FITZSIMONS GATEWAY MULTIFAMILY | SITE PLAN

LOT 2, BLOCK 1 FITZSIMONS PROMENADE SUBDIVISION FILING NO. 1 AMENDMENT 1
LOCATED IN THE NORTHWEST 1/4 OF SECTION 1, TOWNSHIP 4 SOUTH, RANGE 67 WEST OF THE 6TH P.M.,
CITY OF AURORA, COUNTY OF ARAPAHOE, STATE OF COLORADO

AMENDMENTS

DATE:
08/24/22 - SITE PLAN 01
10/17/22 - SITE PLAN 02
11/23/22 - SITE PLAN 03
12/19/22 - SITE PLAN 04
02/13/23 - SITE PLAN 05
05/17/23 - MINOR AMD 01-1
12/08/23 - MINOR AMD 01-2
01/30/24 - MINOR AMD 01-3
12/12/24 - MINOR AMD 02-1
01/06/25 - MINOR AMD 02-2

PLAZA LANDSCAPE ENLARGEMENT

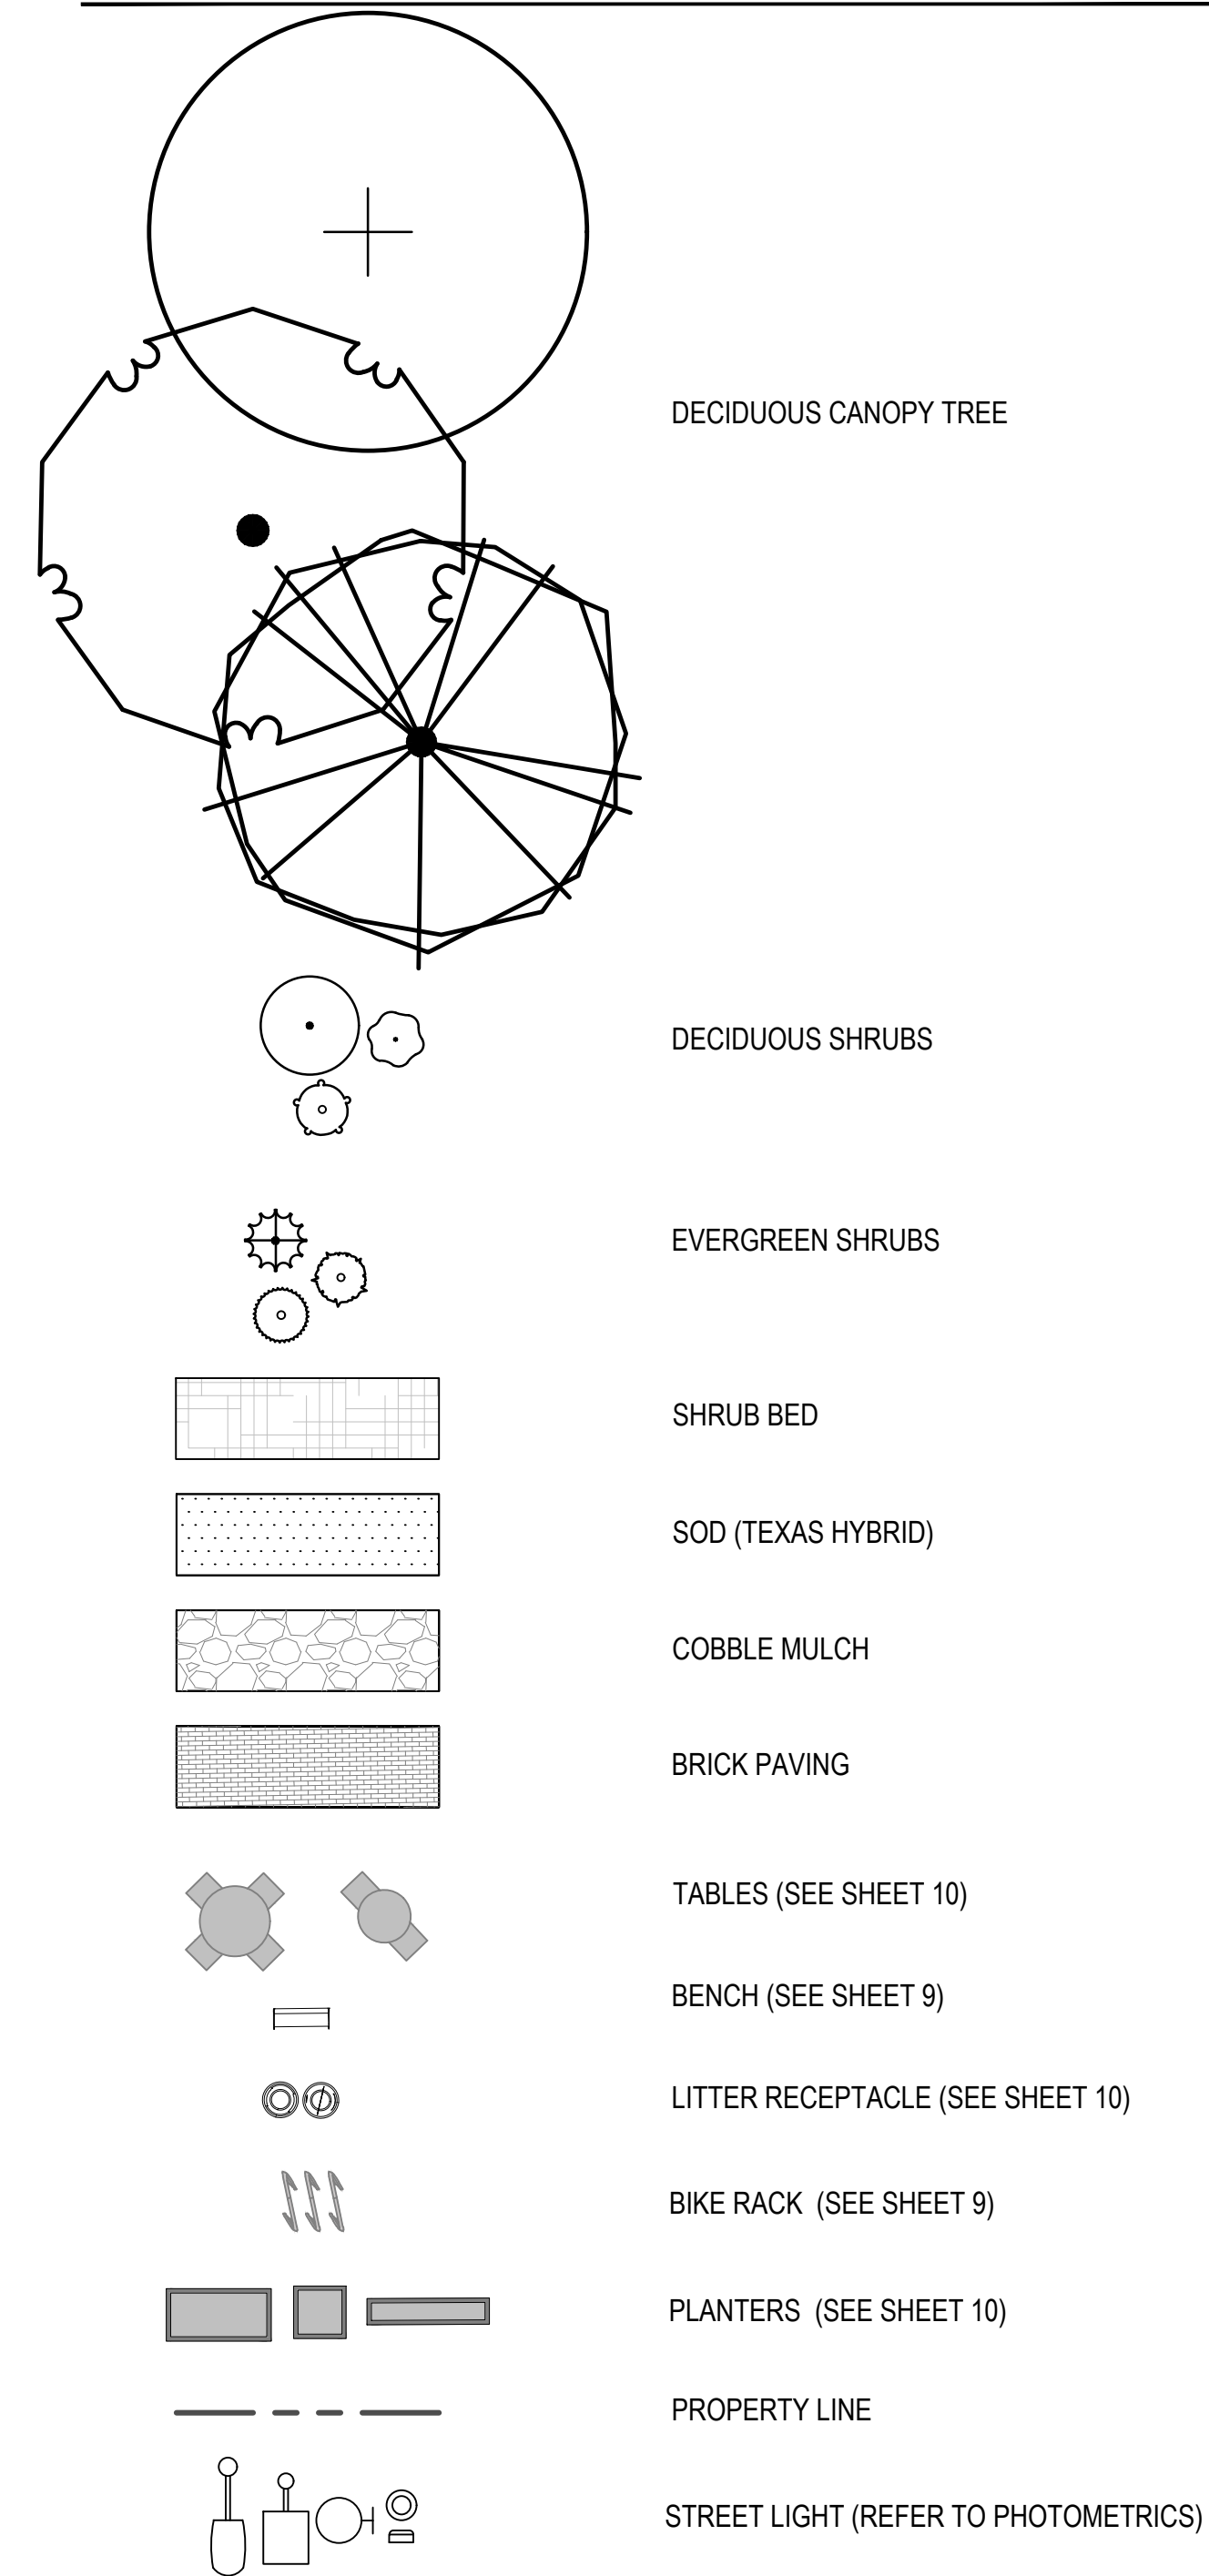
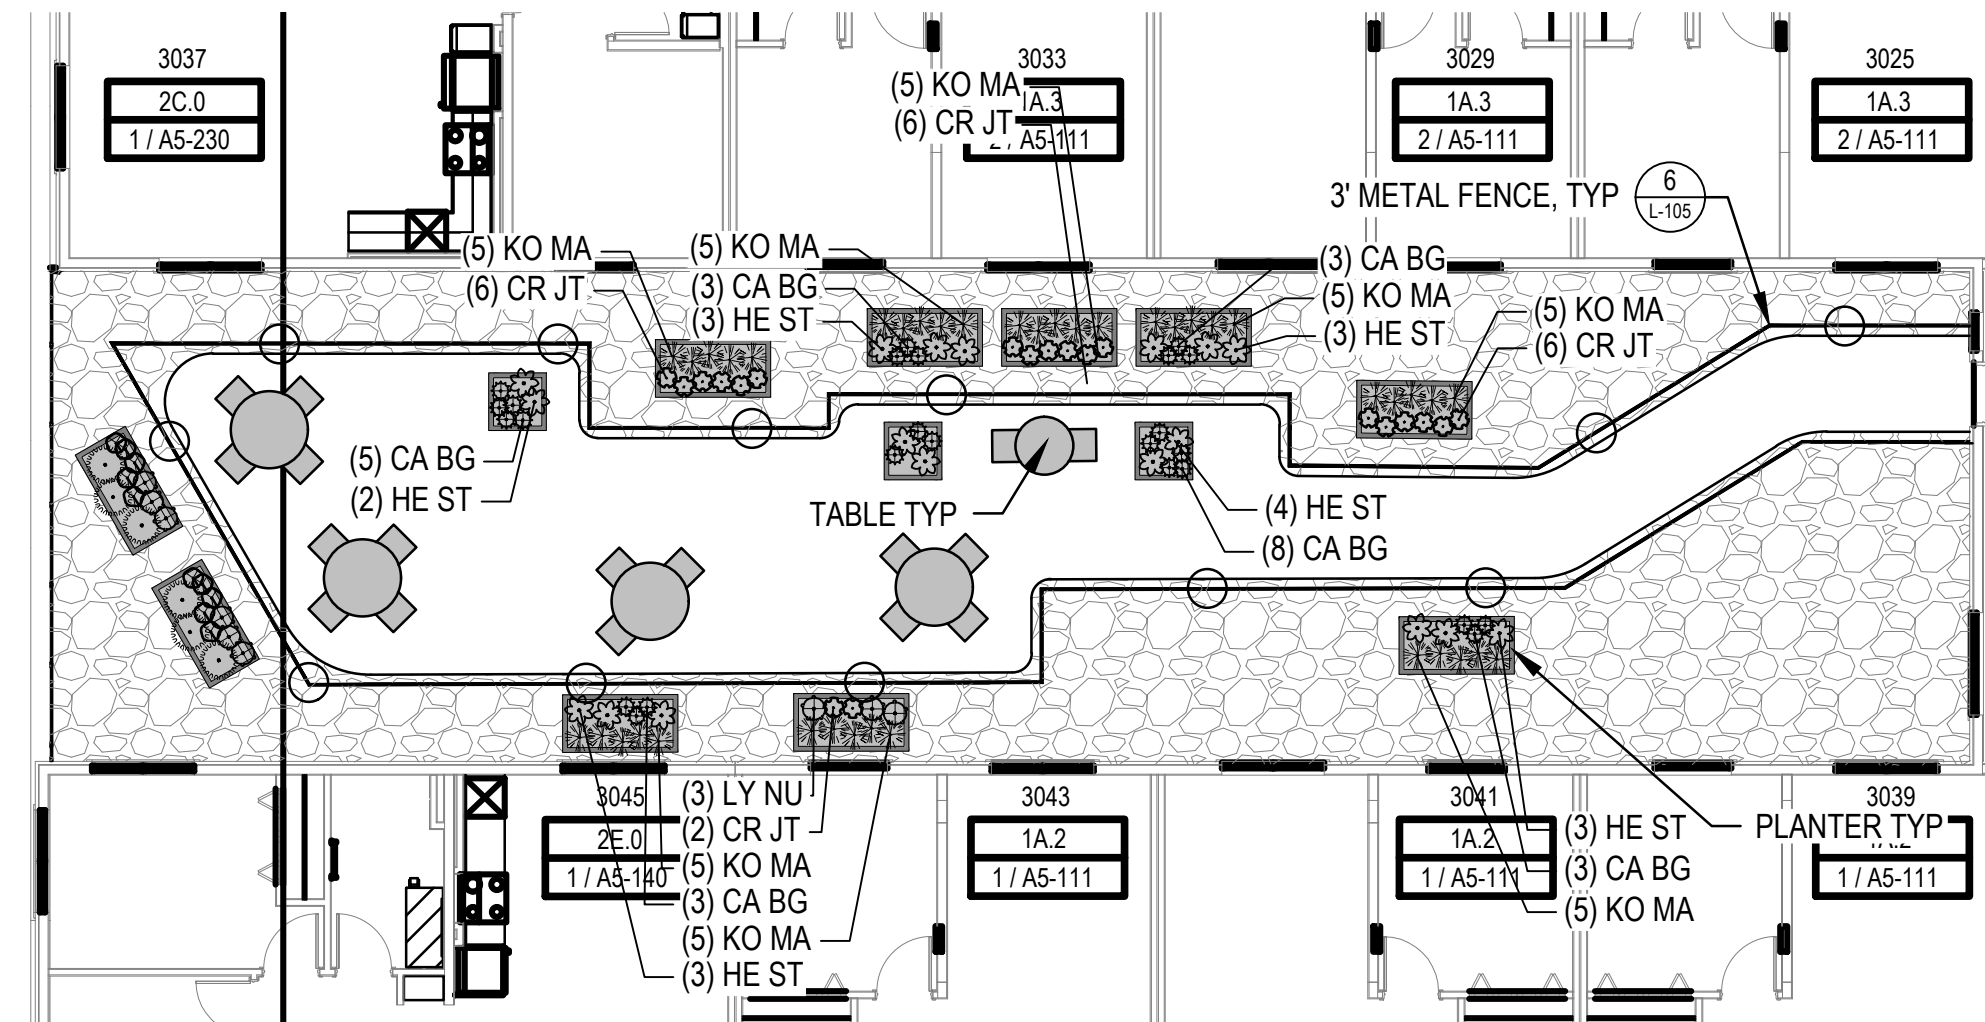
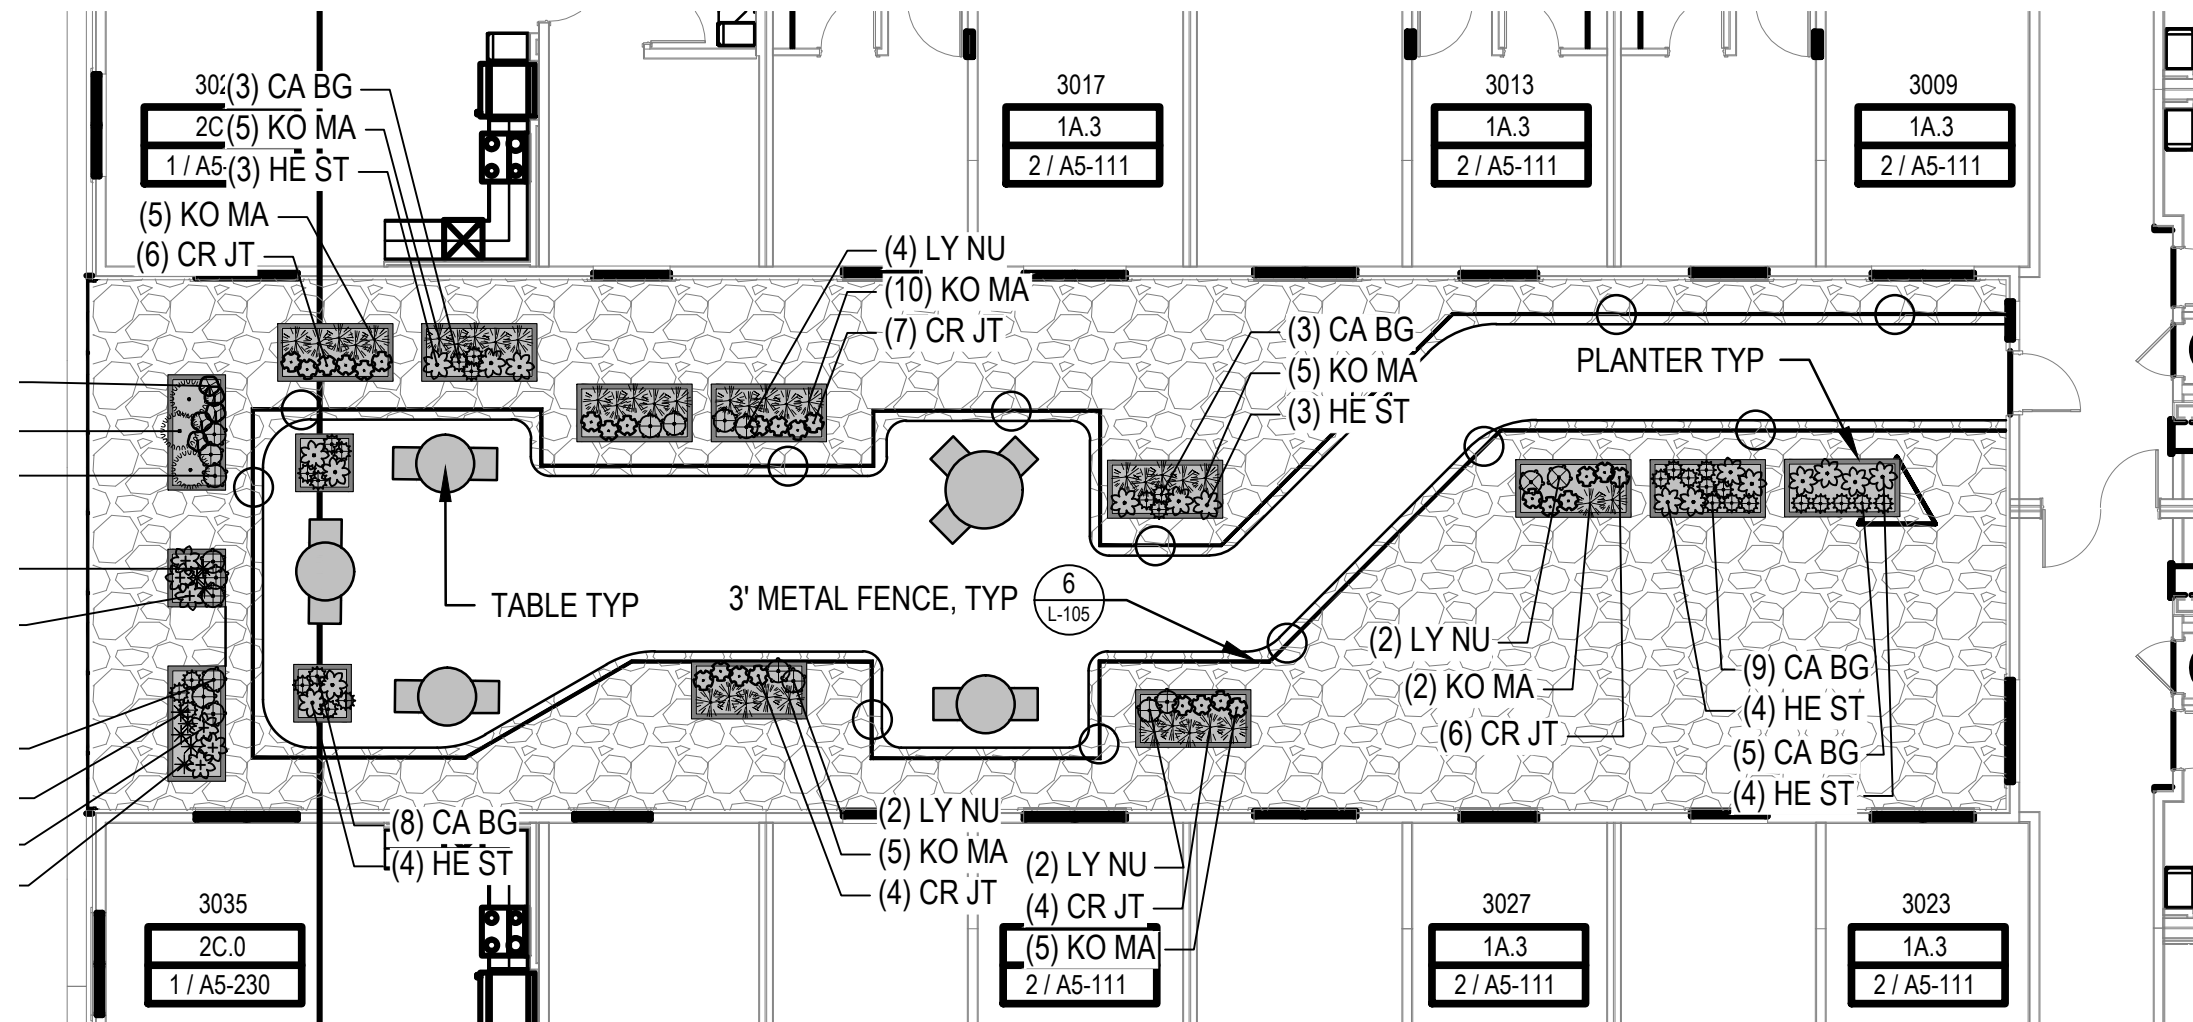
- AMENITY DECK LANDSCAPE PLANTERS AND FENCING REVISED PER COMMENTS RECEIVED DURING BUILDING PERMIT REVIEW. COBBLE REMOVED AND PLANTERS MOVED FURTHER FROM EDGE, FENCING DETAIL REVISED. UPDATES SHOWN ON LANDSCAPE ENLARGEMENTS, LANDSCAPE DETAILS, LEVEL 3 PHOTOMETRIC PLAN.
